RE: Secondary Containment Evaluation and Recommendations  
Nevada Environmental Response Trust  
Henderson, Nevada

**Subject:** NERT – GWETS Piping Secondary Containment

## Review of Above Ground Piping Outside Secondary Containment

Figure No. 5  
DAF Area Uncontained Piping

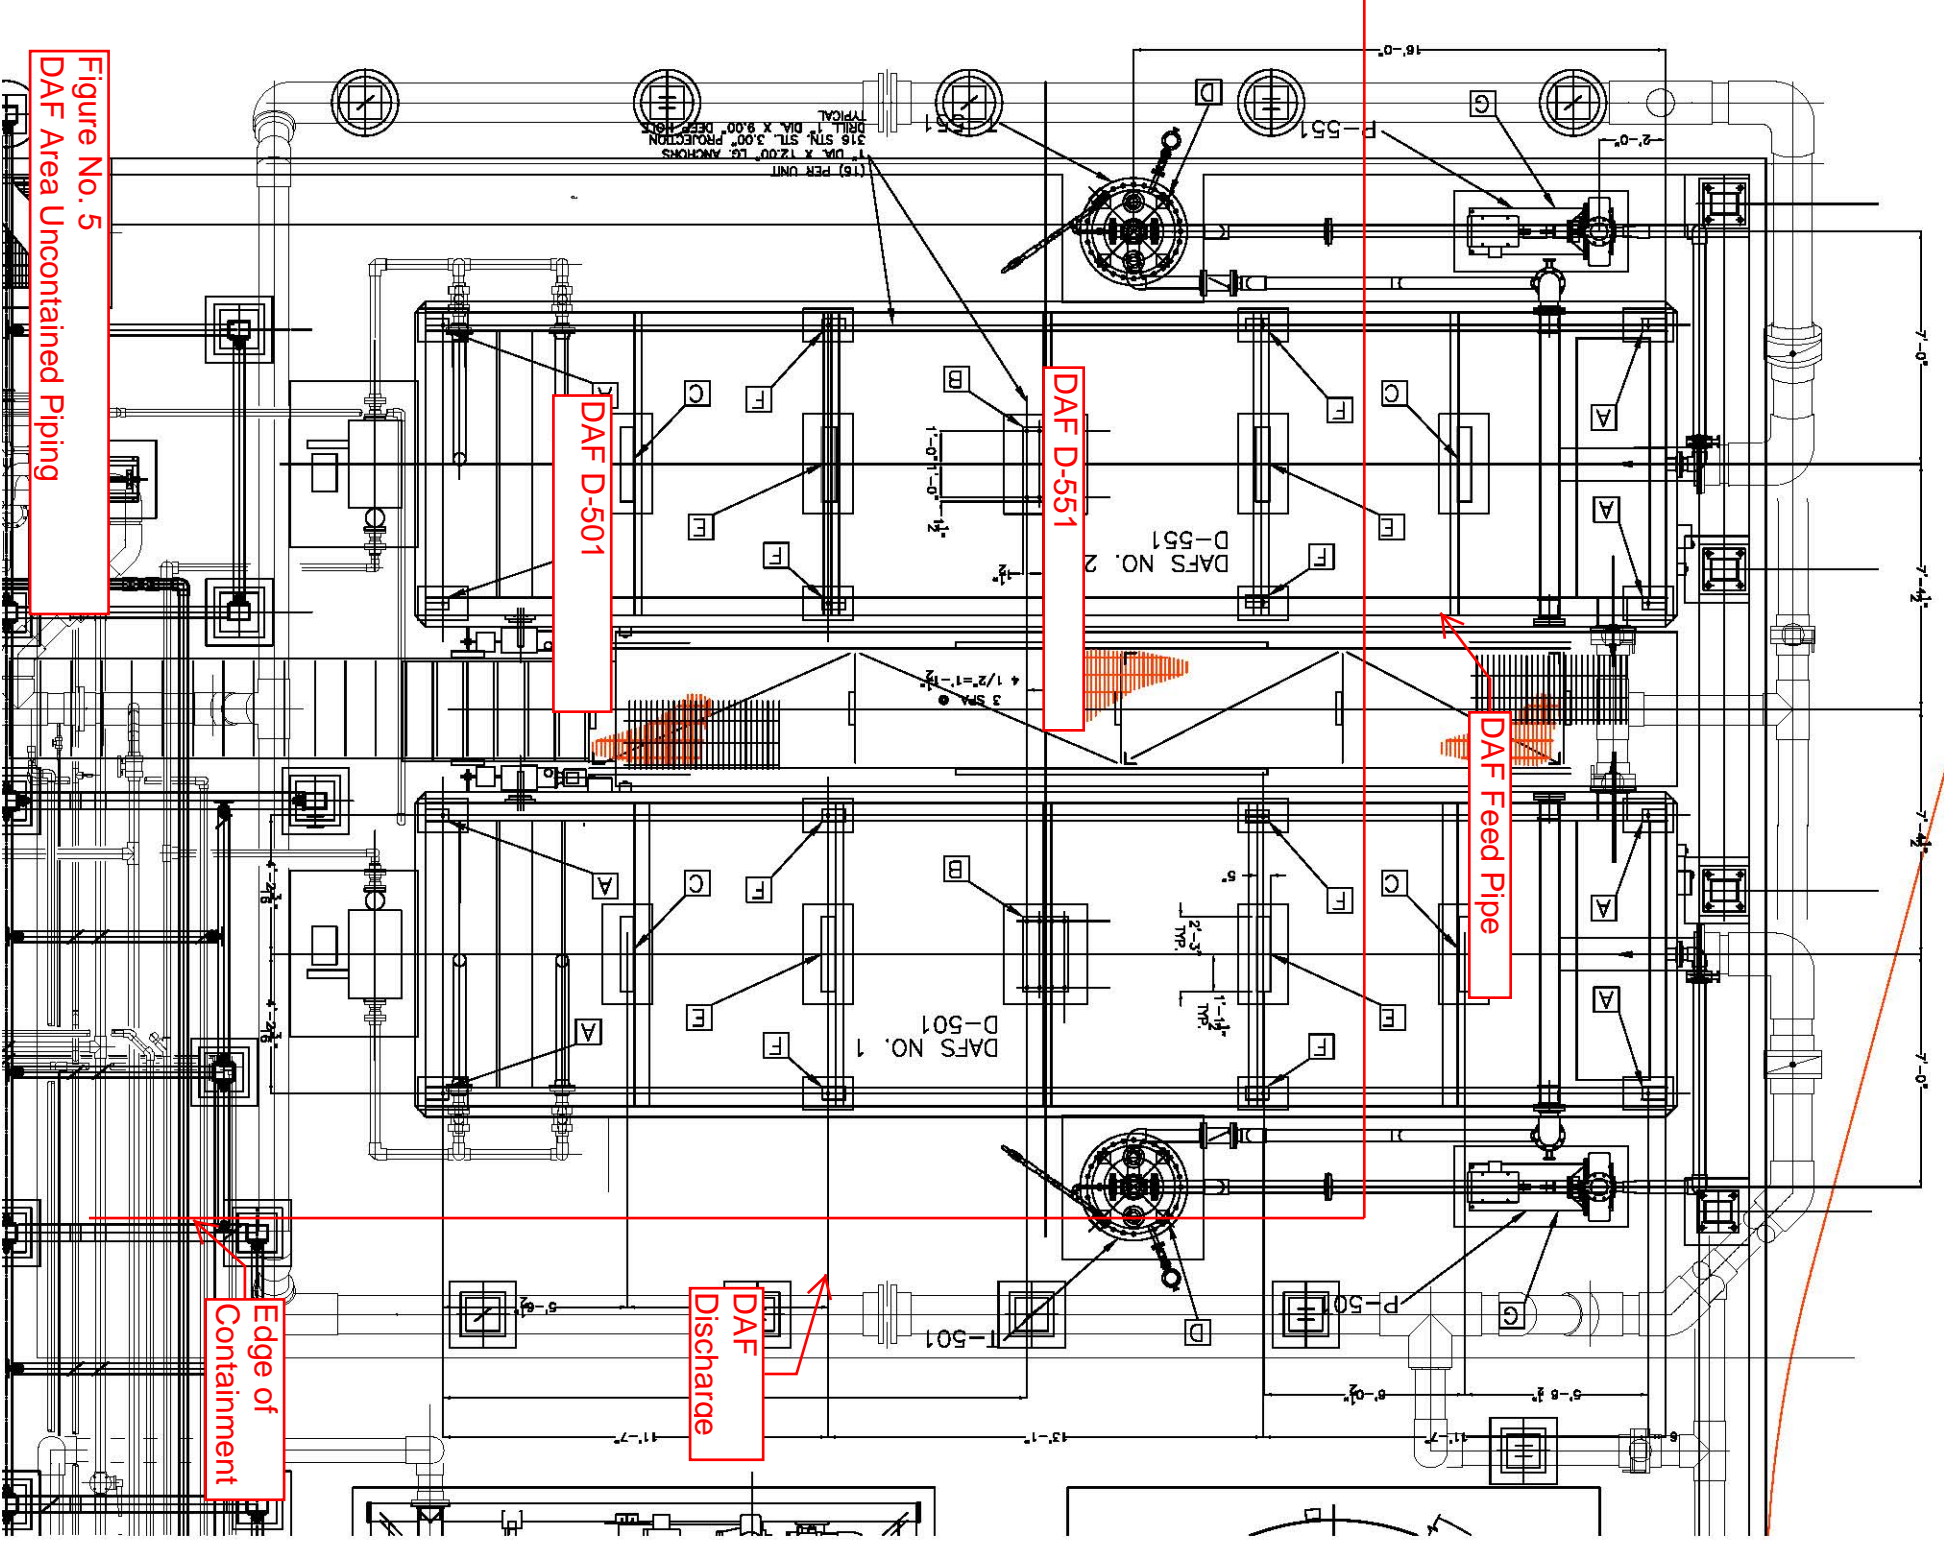
### Figure 5: Identifies DAF feed and discharge piping outside the FBR area containment pad.

- Two pipes carrying raw water between the FBR pad and the D-1 building have been identified: a 3-inch sump discharge pipe (can contain raw water in the event of a spill) and a 10-inch raw water pipe. Tetra Tech recommends installing an asphalt berm and trench drains that would direct flow to a new containment sump constructed north of the D-1 building. The DAF discharge and feed piping and the sludge piping outside of the FBR containment pad in the area between the FBR pad and D-1 building is partially treated water and will not contain detectable concentrations of perchlorate, but a portion will be included within the containment for piping between the FBR pad and the D-1 building.

Figure No. 9  
Lift Station No. 2

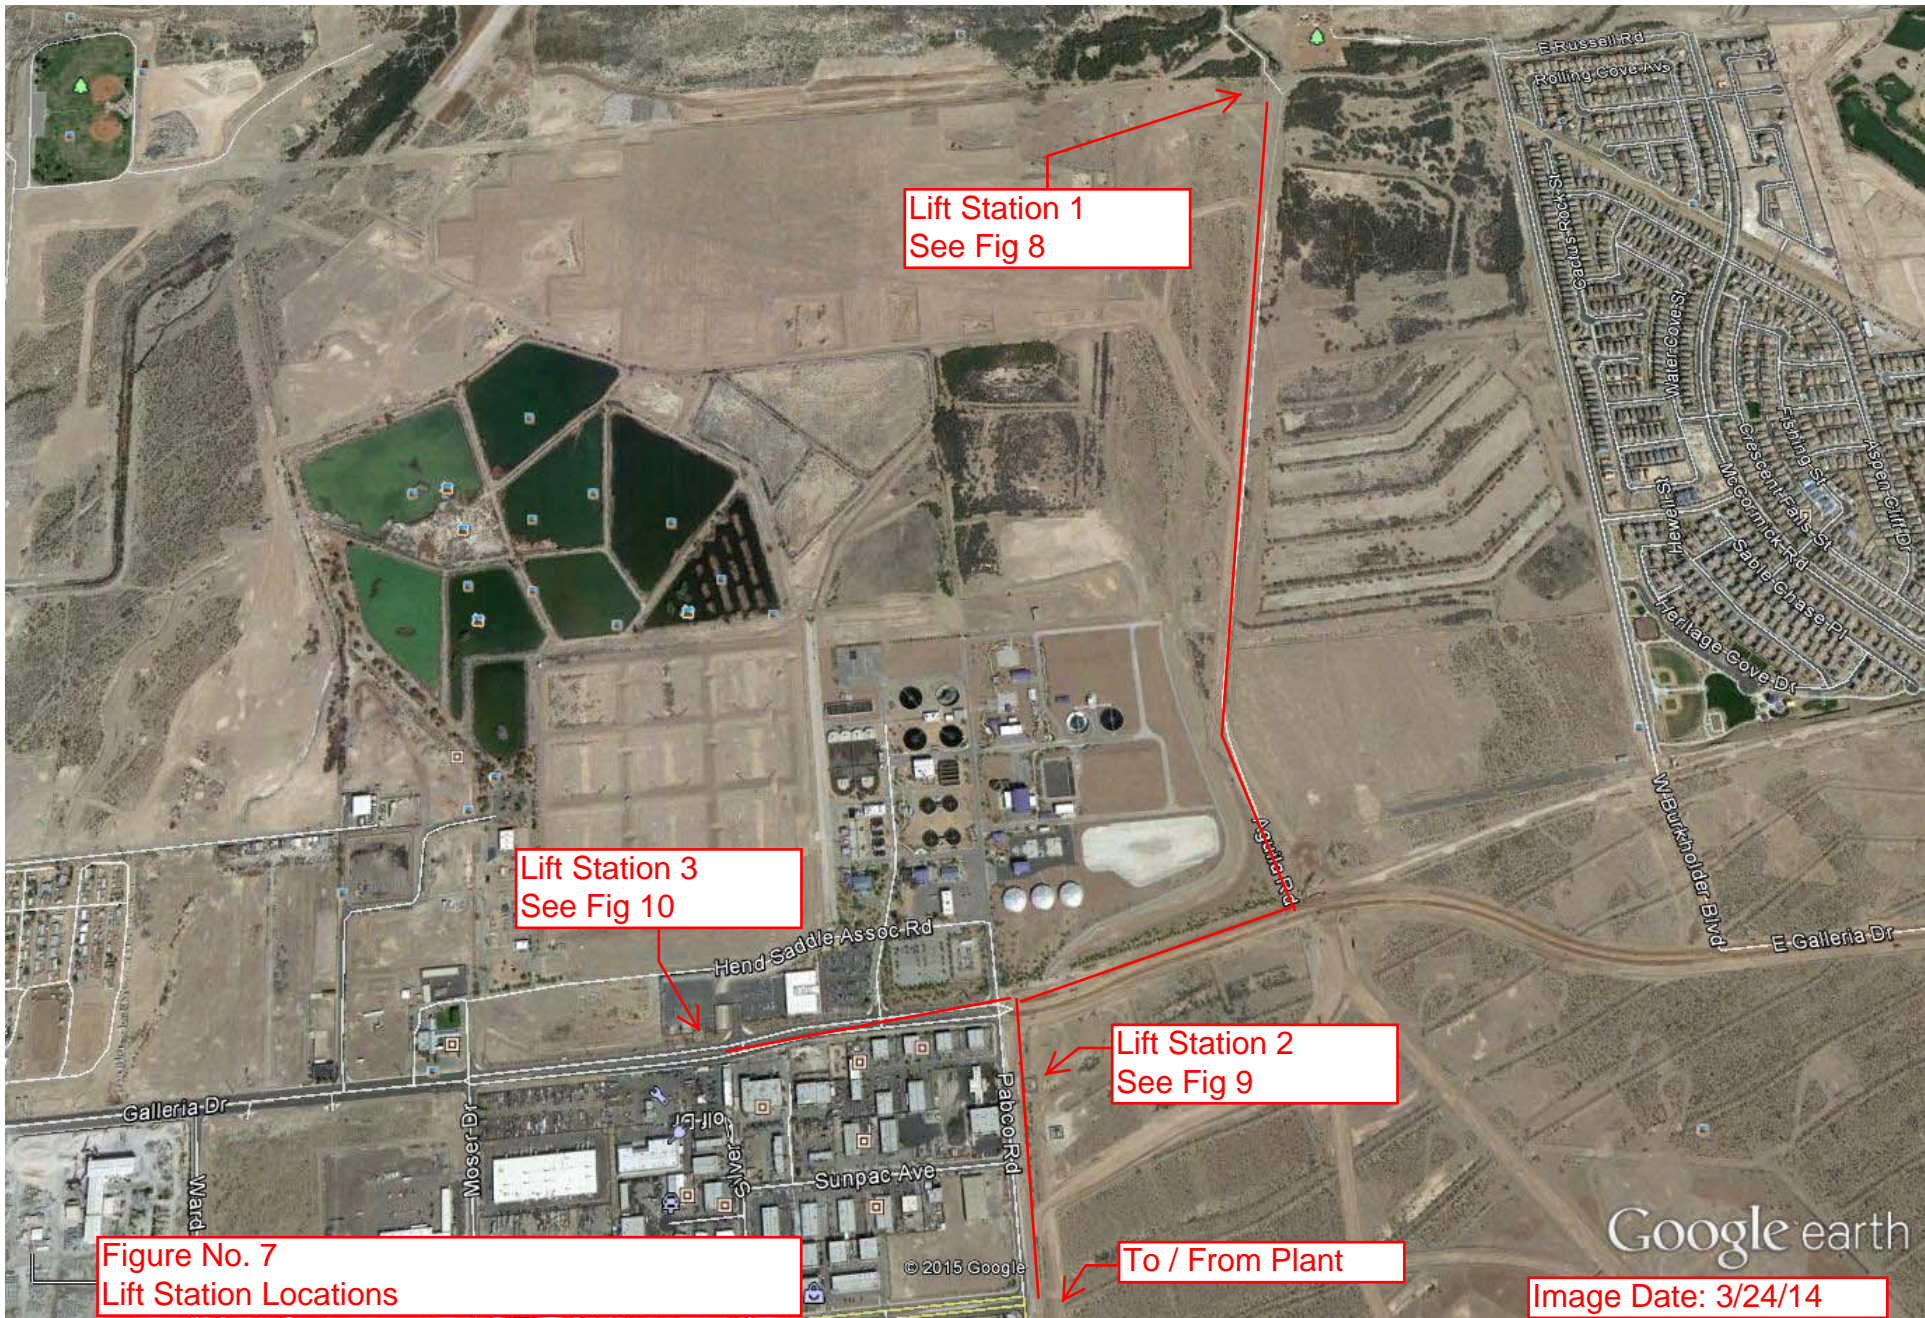
Figure 9: Identifies surface piping at Lift Station No. 2. Discharge continues to the treatment plant.

- Lift Station 2 has a single 6-inch, above ground raw water pipeline. This pipe is the discharge from the higher capacity vertical turbine pump. There are plans to replace the lower capacity submersible pump. It is recommended that the raw water piping be rerouted and containment added during the pump replacement project.
- Lift Station 3 does not have above ground piping needing secondary containment.
